Staff Report and Recommendations Agenda of January 24, 2022, Item 7a

A request for a Certificate of Review (COR) from the Cultural Heritage Board (CHB) (Ventura County Cultural Heritage Ordinance [CHO] §1364-12] for a 609-square-foot addition to an existing single-family dwelling located at 387 Park Street, Piru, CA 93040 (Floyd Warring Residence; Site of Merit). The addition would increase the floor area of the master bedroom and add a basement underneath the master bedroom with exterior access. (Case No. CH21-0046).

837 Park Street, Piru, CA 93040 (unincorporated Ventura County) Assessor's Parcel Number (APN): 056-0-030-150 Historic Designation: Site of Merit Common/Historic Name: Floyd Warring Residence

Figure 5 – Proposed Site Plan

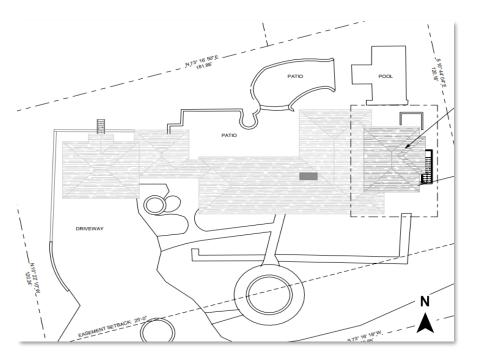
The proposed project will be set back from the main residence's primary facade. As proposed, the addition will have limited to no visibility from Park Street. Park Street is a private street with no public view. Should the proposed addition be removed in the future, the essential form, setting, and integrity of the Site of Merit as an individually eligible resource and as a contributor to an eligible historic district will generally be preserved.

### Figure 6 – Proposed Addition (East Elevation)

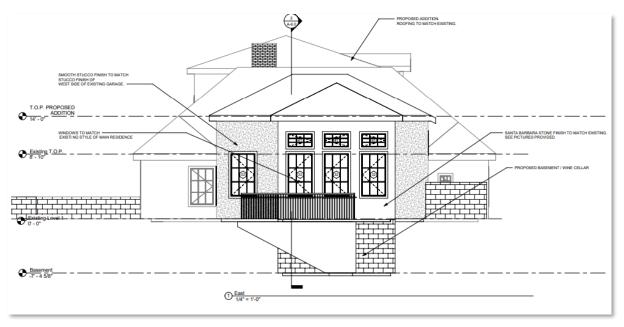
Standards	Staff Comments
	mostly compatible with the existing French Revival style of the main residence but differentiated. The design of the proposed addition will incorporate some elements found in the main residence's design such as the stone siding, slate roofing tiles, multi-lite steel casement windows (eastern elevation), and similar hipped roof style, but the proposed building's windows will be dual-paned and will not be recessed due to the absence of wall thickness. The proposed building will have a modest hipped roofline with limited detailing compared to that of the main residence.
	However, the proposed windows and doors on the north and south elevation would not have a pattern of divided lites similar to those of the main residence. In CHB Staff's view, the modern, fixed windows and doors do not appear to meet this Standard. Based on the above, Staff determined this Standard has been partially met.

massing, size, and scale of the main residence. However, the proposed windows and doors on the north and south elevation would not have a pattern of divided lites similar to those of the main residence. In CHB Staff's view, the proposed modern, fixed windows and doors do not appear to be sufficiently compatible. Alternatively, a pattern of divided lites with different proportions or dimensions than those on the main residence would appear compatible, yet differentiated.
